Subject: **Remediation and Closure Report**
Judah Oil, LLC
Oxy T-Bone Federal #1 SWD
API # 30-015-32122

From: Van Curen, Jennifer [jvancure@blm.gov]
Sent: Tuesday, January 28, 2014 10:11 AM
To: David Adkins
Subject: Re: work plan, notice to proceed, Judah Oil T-Bone Fed 1
Attachments: DOC008.PDF

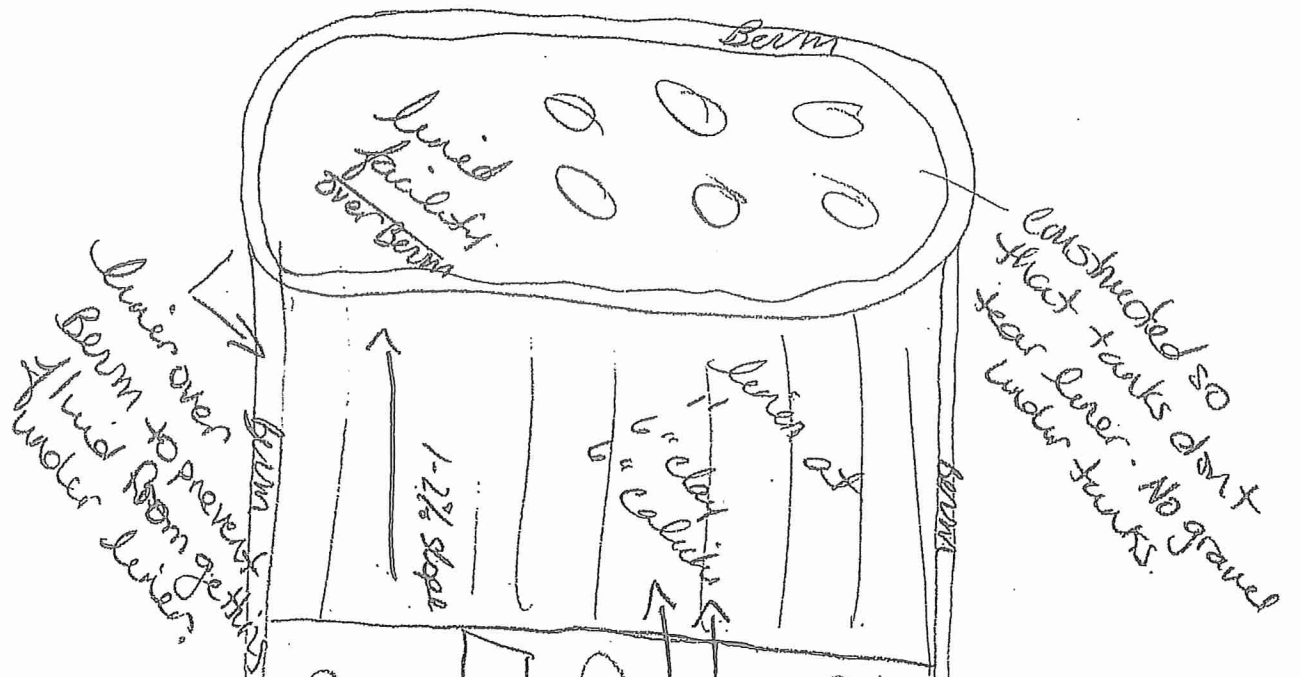
This is going to be an extensive cleanup, so I would like to add a couple of steps to prevent this event in the future. I have attached a hand drawn sketch. The step is not going to cost much more, but will save from the cost of this clean up from happening again. If bottom samples come back less than 2500 at 8' with cls not increasing below that point, I do not see the point of placing a liner. I will require a liner at surface for the facility. I will also require the liner be protected from puncture from beneath or on top. The tanks will need to be placed on something other than gravel to protect the liner. I will also require the pumps and other leak potential equipment to be inside the lined secondary containment.

For the exterior, if you get the cls below 2000 at 3' or deeper and the cls at lower depths do not rise above that, I will not require a liner. I would recommend the liner at 1' below surface. I would then place 6" of clay and then 6" of caliche. Yes the liner is there, but by having the caliche first, this could prevent hydrocarbons from being any more than a scrape of pad. If there is only PW, you know that the most you will have is the 6" due to the fact that PW alone is held very well by clay as long as hydrocarbons do not exist. Again this is a step of prevention from digging and hauling large amounts of contaminants. Even though the liner is at 1', wildlife will still need to be protected from any contaminants on the surface. And scraping is much more economical. I hope this is explained well enough. Again, I don't feel that there will be any more expense since most of the contaminants should be clean enough without a liner at the lower depth.

Constructed so that tanks don't tear liner. No gravel under tanks.

Liner over berm to prevent fluid from getting under liner.

check dam to hold leachate
leachate collection system
Top
Bottom

leachate collection system
gravel area

All surrounding should include in lined area
be in secondary containment
No pits
